# Access Compliance Report

## Public Rights-of-Way

Intersection ID: 11698	Main Street: S_CEDAR_ST	Cross Street: W_4TH_ST	Location: S
ADA ID: 36EBDF4A0165	Ramp Type: PerpDiag	Initial Pass/Fail: Fail	Overall Compliance: No
		Severity Score: 25

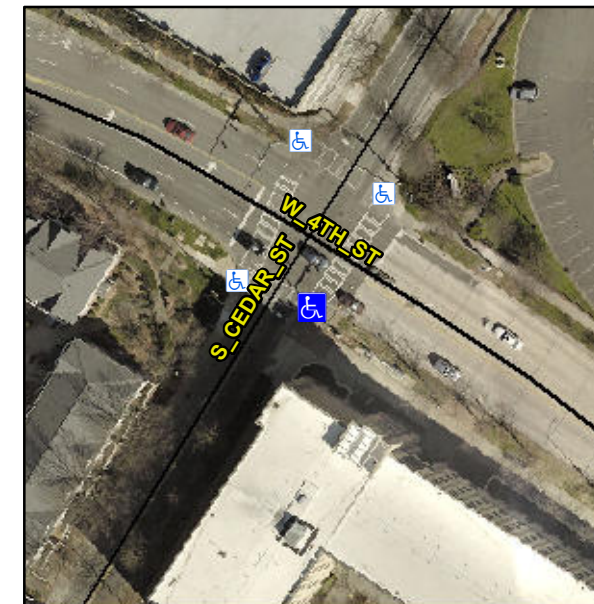
**Not Found, R304.2.2, R304.5.3**

Compliance	Description	Data	Compliance	Description	Data
N/A	Ramp Length (in)	60.0	No	Ramp Slope (%)	9.6
Yes	Ramp Width (in)	68.0	No	Ramp XSlope (%)	6.0
N/A	Flare Type LT	N/A	N/A	Flare Type RT	N/A
N/A	Flare Slope LT (%)	N/A	N/A	Flare Slope RT (%)	N/A
N/A	Flare Traversable LT?	N/A	N/A	Flare Traversable RT?	N/A
N/A	Landing Length (in)	N/A	N/A	DWS Provided?	N/A
N/A	Landing Width (in)	N/A	N/A	DWS Contrast?	N/A
N/A	Landing Slope (%)	N/A	N/A	DWS Length (in)	N/A
N/A	Landing X Slope (%)	N/A	N/A	DWS Full Width?	N/A
N/A	Landing Curb? (Y/N)	N/A	N/A	DWS Offset (in)	N/A
N/A	Shared Landing?	N/A			
N/A	Gutter Ponding?	N/A	N/A	Gutter Slope (%)	N/A
N/A	Gutter Lip Ht (in)	N/A	N/A	Gutter X Slope (%)	N/A
N/A	Painted X Walk1?	Yes	N/A	Painted X Walk2?	Yes
	X Walk 1 Direction	To NE		X Walk 2 Direction	To NW
N/A	X Walk 1 Width (in)	109.0	N/A	X Walk 2 Width (in)	102.0
	X Walk 1 Slope (%)	2.8		X Walk 2 Slope (%)	2.5
	X Walk 1 X Slope (%)	1.2		X Walk 2 X Slope (%)	2.4

**Remove & Replace Curb Ramp With Two New Directional Ramps or Equivalent.**
